PHX Sky Train
Stage 2 Design
500 S. 24th St.
Phoenix, AZ 85034

Subject: **Additional Perimeter Lighting**

Reference Document: **Bulletin 0010**

Bulletin 0010

RCC STATION
LIGHTING FLOOR PLAN
ELECTRICAL
ROOF PERIMETER LIGHTING PLAN

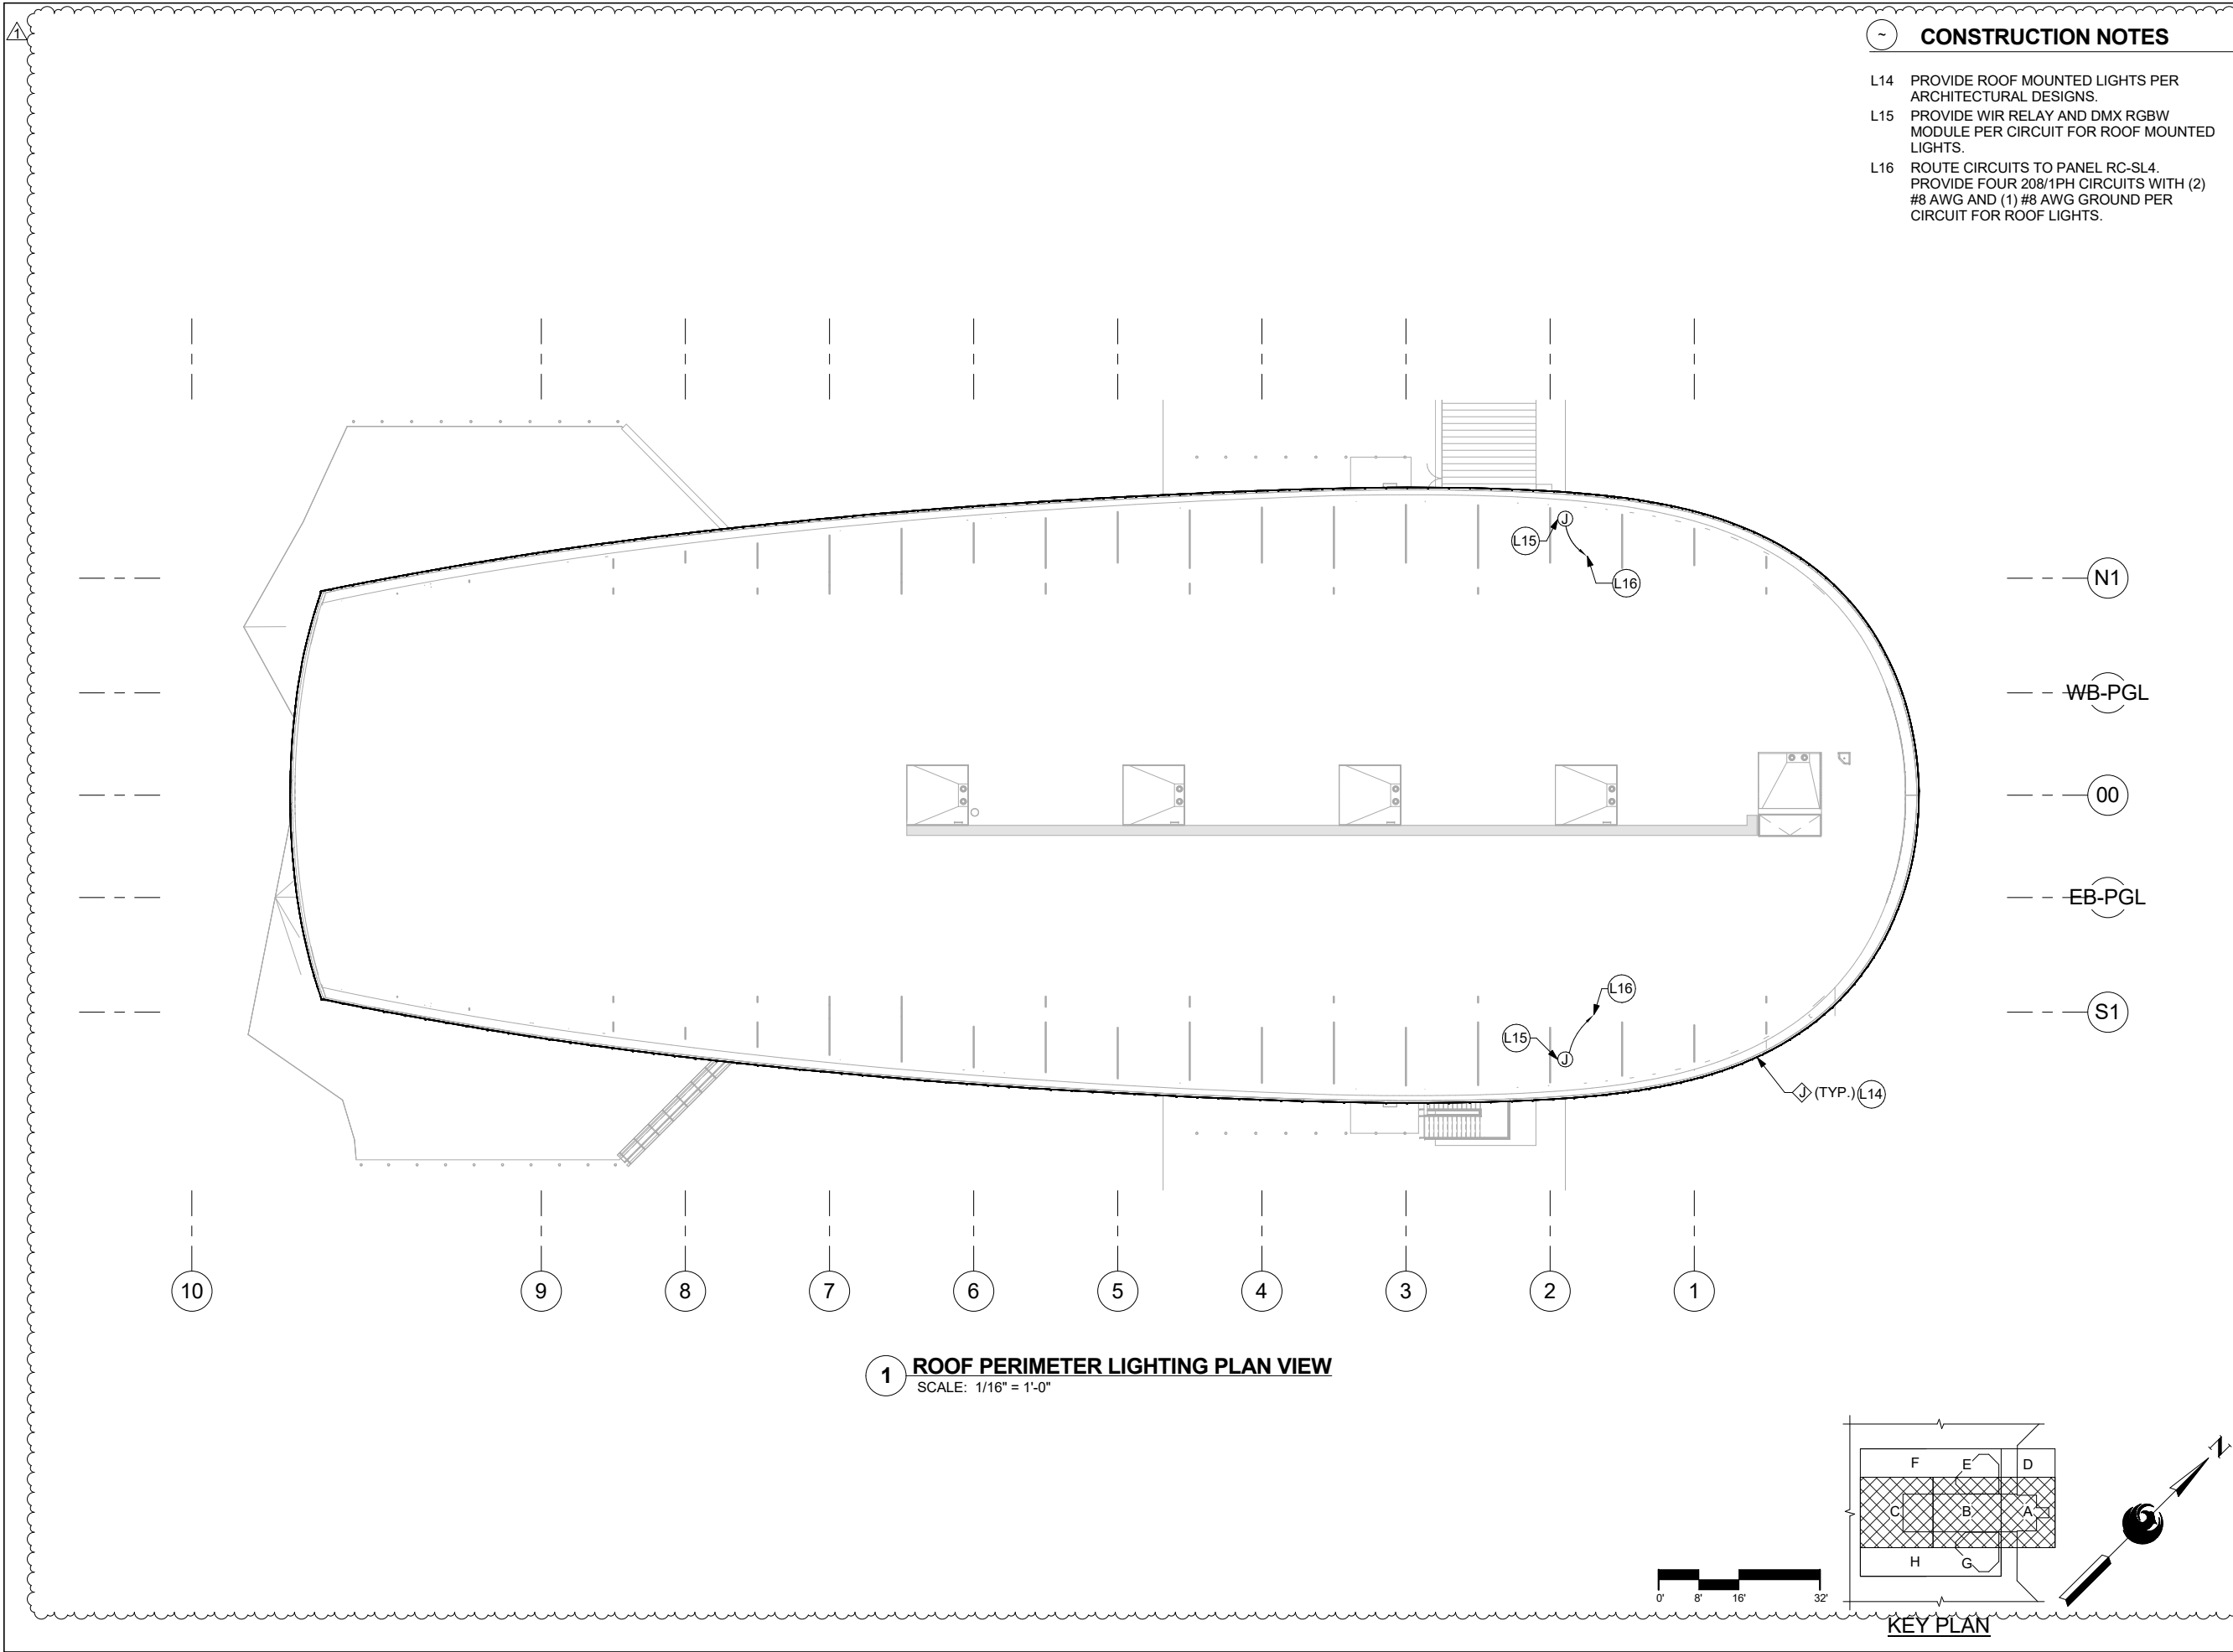
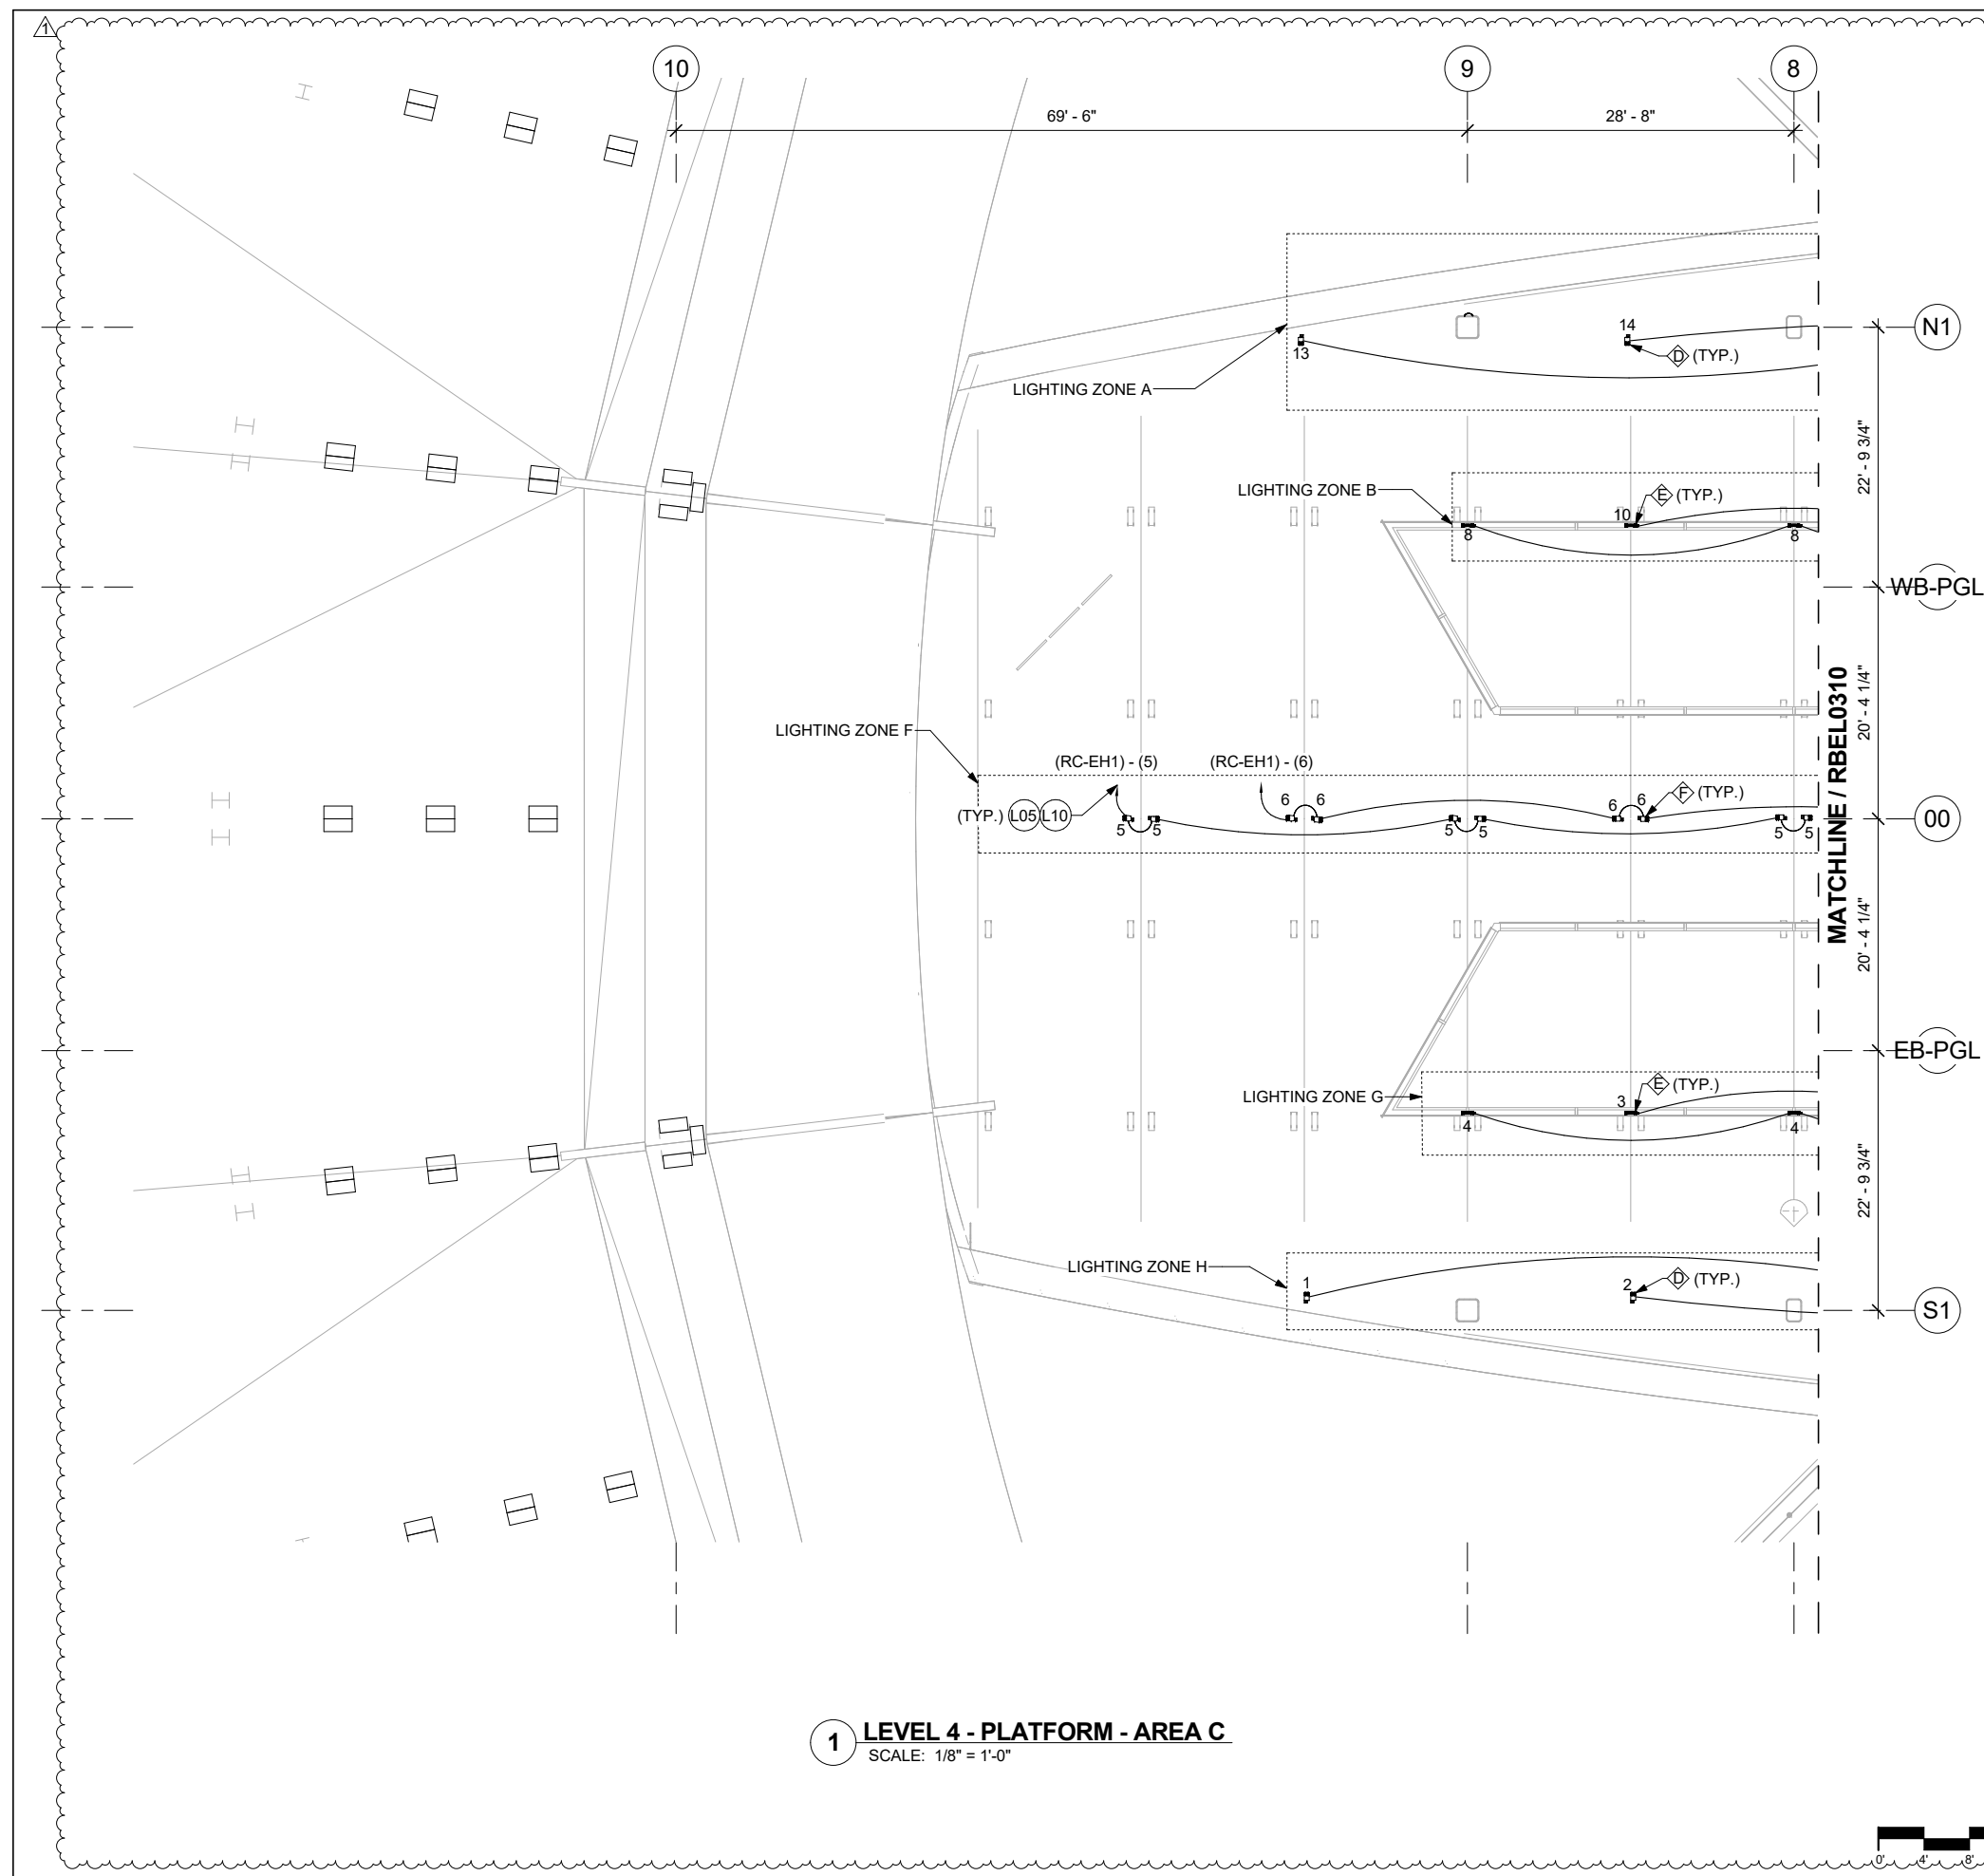
Bulletin 0010: Reference drwg sheet 0052A - RBEL0314 for added perimeter lighting.

- L14 PROVIDE ROOF MOUNTED LIGHTS PER ARCHITECTURAL DESIGNS.
- L15 PROVIDE WIR RELAY AND DMX RGBW MODULE PER CIRCUIT FOR ROOF MOUNTED LIGHTS.
- L16 ROUTE CIRCUITS TO PANEL RC-SL4. PROVIDE FOUR 208/1PH CIRCUITS WITH (2) #8 AWG AND (1) #8 AWG GROUND PER CIRCUIT FOR ROOF LIGHTS.
